LEE'S SUMMIT
MISSOURI
Development Services Department

Development Services Staff Report

File Number	PL2024-157
File Name	REZONING from R-1 to PMIX – Discovery Crossing, Lots 1-9
Applicant	Intrinsic Development, LLC, applicant
Property Address	1810 NE Douglas St and 101 NW Colbern Rd
Planning Commission Date	September 12, 2024
Heard by	Planning Commission and City Council
Analyst	Hector Soto, Jr., AICP, Senior Planner

Figure 1 - Site Plan

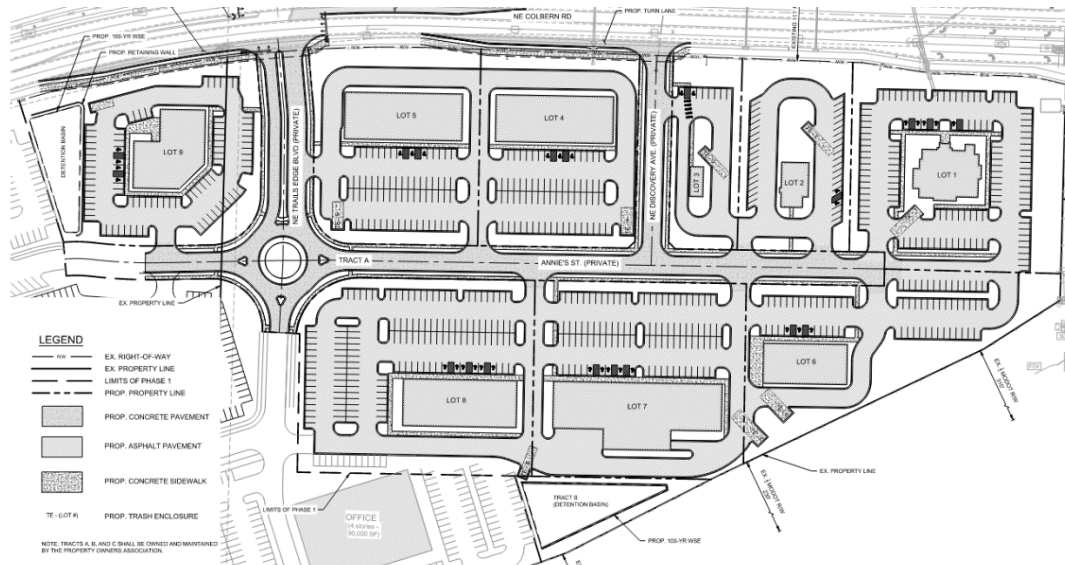
The buildings on Lots 7 and 8 exceed 300 feet to a hydrant measured from the most exterior portion of the building.

The distance to a hydrant exceeds 100 feet on Lots: 1,2,3,4,5,6,7,8 and 9.

The building on Lot 9 does not meet the requirement. Provide hydrants or adjust spacing to meet requirements. Provide hydrants along the north side of NE Colbern Road.

Figure 7 - Proposed reduced parking lot setback area.

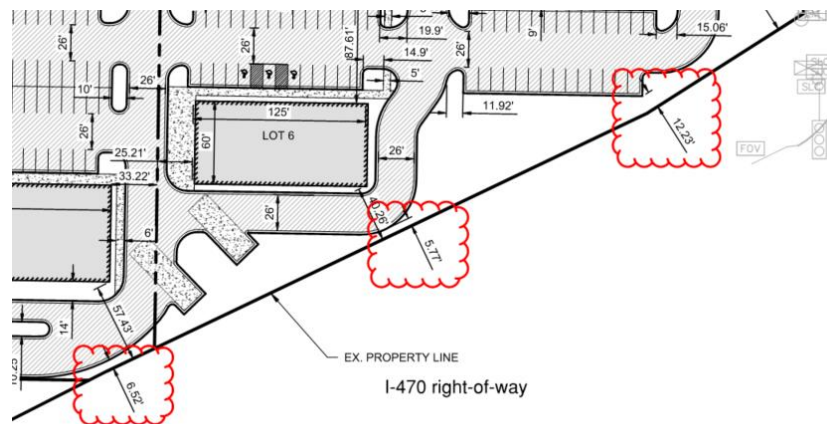
The applicant is seeking a modification to UDO Section 8.620 pertaining to the required 20' parking lot setback. Staff has reviewed the request and supports the requested modification for the reasons identified below.

- Required – minimum 20' setback from the right-of-way
- Proposed – 5.77' setback from the I-470 right-of-way
- Recommended – The area with proposed reduced parking lot setbacks are along the westbound I-470 on-ramp where there is an abundance of right-of-way width that provides ample separation between the parking lot boundaries and the on-ramp lanes travel lanes. More specifically, the parking lot boundaries will maintain between approximately 60' (on the east end of the development) and 100' (near the mid-point of the development) of separation to the abutting I-470 on-ramp, compared to approximately 35' of separation between a parking lot boundary and the nearest edge of street pavement along a typical collector or arterial street. The proposed parking lot with reduced setbacks along the south project boundary will maintain greater separation from the adjacent on-ramp travel lanes than a typical commercial site. Staff supports the modification request.

1. A modification shall be granted to the minimum 20' parking lot setback from the right-of-way, to allow a minimum 5.77' parking lot setback along the I-470 right-of-way.
2. Development shall be in accordance with the preliminary development plan with a revision date of July 26, 2024; landscape plan with a revision date of July 30, 2024; architectural renderings uploaded June 20, 2024; and design guidelines prepared by the developer uploaded June 20, 2024.
3. The development standards (e.g. setbacks, building heights, lot sizes, etc.) and range of allowable land uses that will govern the subject PMIX development shall be the established development standards and allowable land uses of the CP-2 zoning district.
4. Development shall be in accordance with the recommended road improvements included in the TIA dated, August 28, 2024, prepared by Erin Ralovo, P.E., Senior Staff Engineer.
